2B	**Reviewed. Comments enclosed. Incorporate the comments and re-submit for review.**

UNLESS OTHERWISE SPECIFIED: DIMENSIONS ARE IN MILLIMETERS SURFACE FINISH: TOLERANCES: LINEAR: ANGULAR:			FINISH:		DEBURR AND BREAK SHARP EDGES	NIHVA NIHVA Technologies Pvt. Ltd.
	NAME	SIGNATURE	DATE			TITLE: GA. WIERFRAME DRAWING
DRAWN						
CHK'D						
APPV'D						
MFG						
Q.A				MATERIAL:		DWG NO. A0
				WEIGHT:		SCALE:1:100 SHEET 1 OF 1

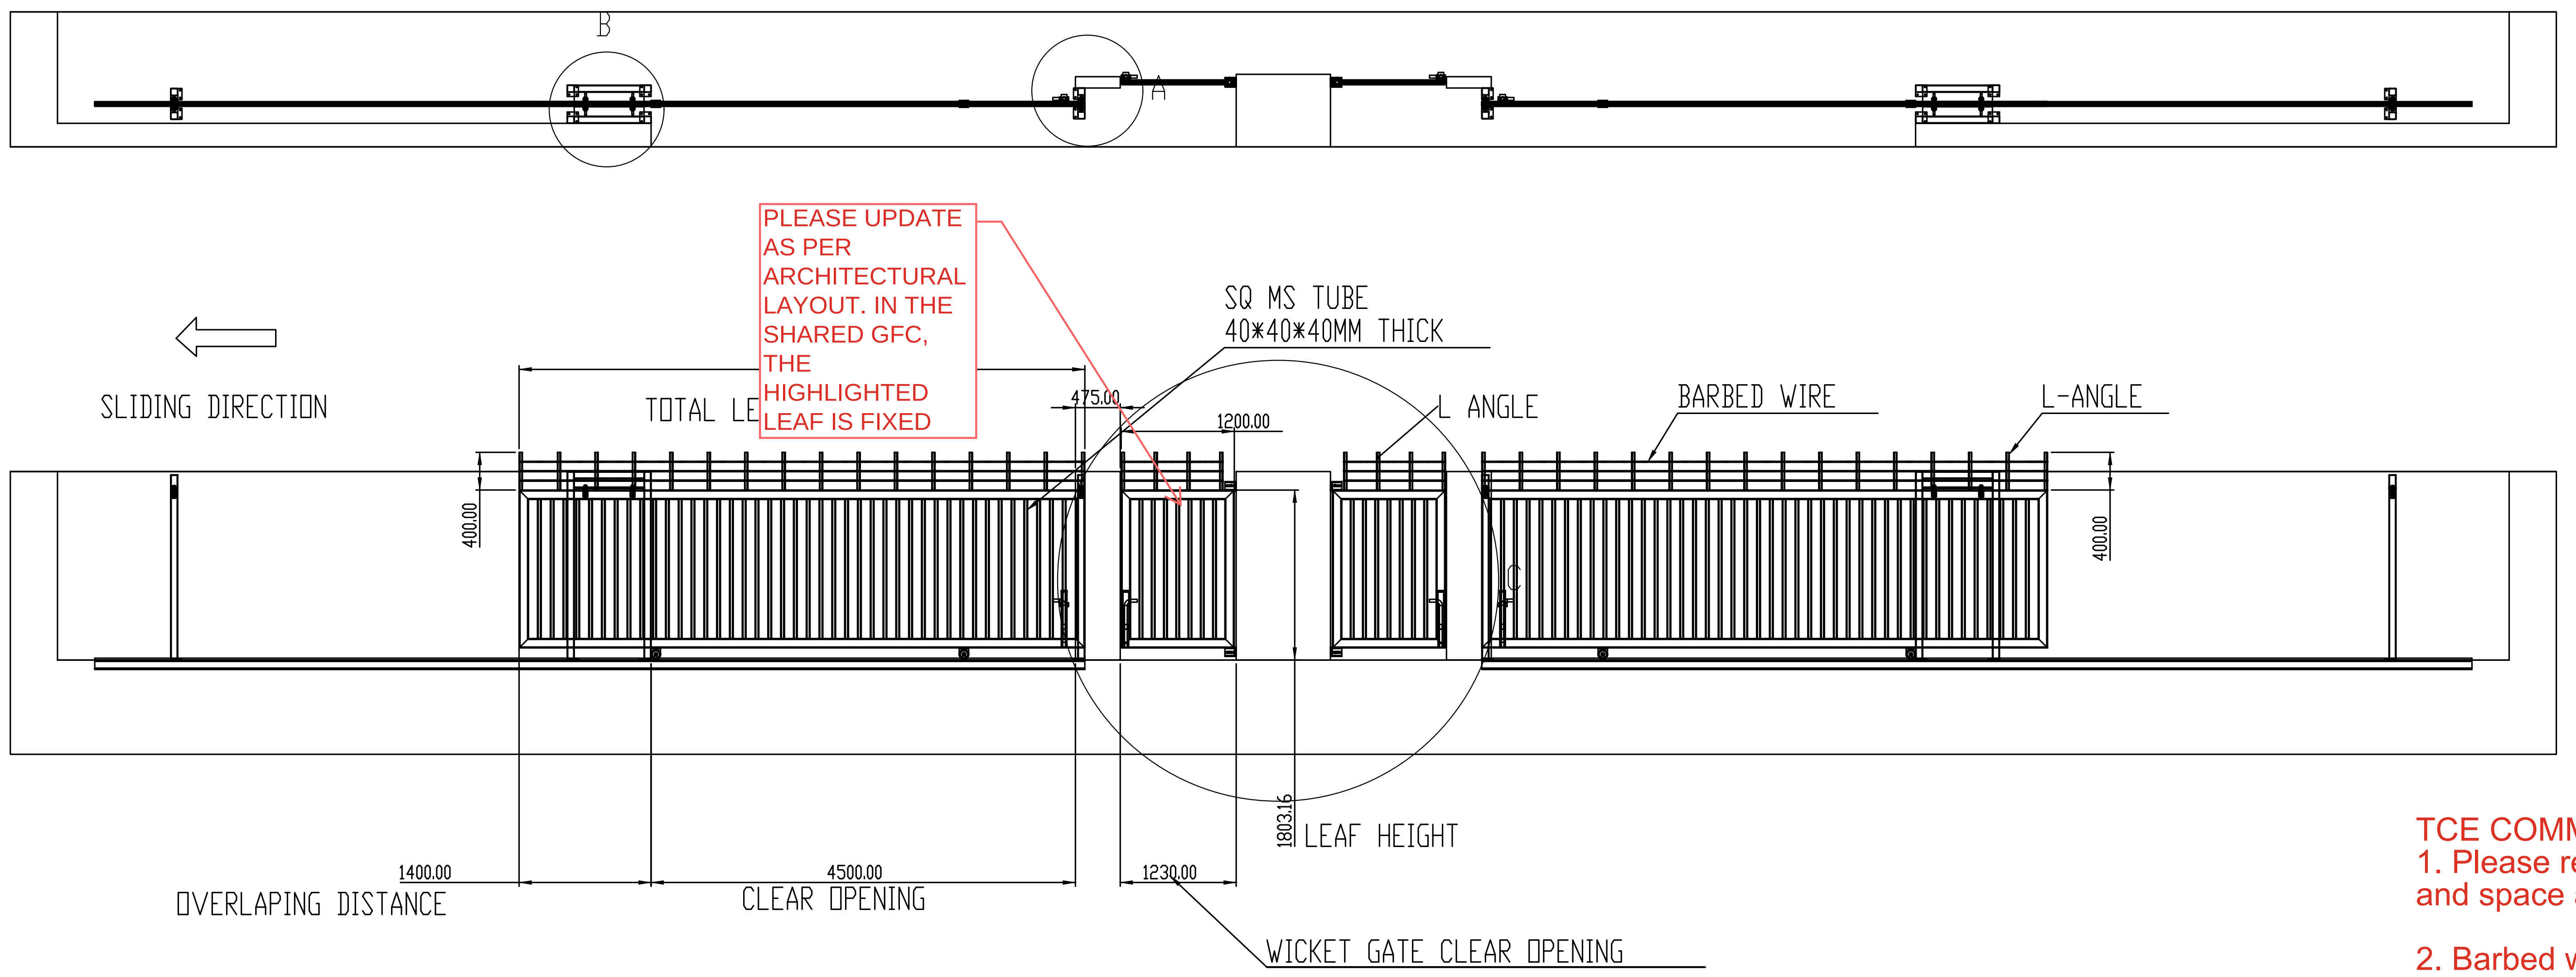
PLEASE UPDATE AS PER ARCHITECTURAL LAYOUT. IN THE SHARED GFC, THE HIGHLIGHTED LEAF IS FIXED

TCE COMMENTS :
1. Please refer to the latest master layout for the exact site dimensions and space availability.

2. Barbed wire fencing above the sliding gate is under finalization with the Air India team. TCE will confirm shortly.

3. Please specify whether the elevation view is from the inside or outside. It is currently unclear.

4. As the door sizes are as per the requirement, kindly consider the weight and design the sections accordingly.
Also, the wheel should be a double wheel, as shown in the architectural layout.
Locking arrangement details are missing from the GA drawing.
5. Kindly update as per the architectural layout: Sliding Gate Type 04 is to be shown without barbed wire fencing.
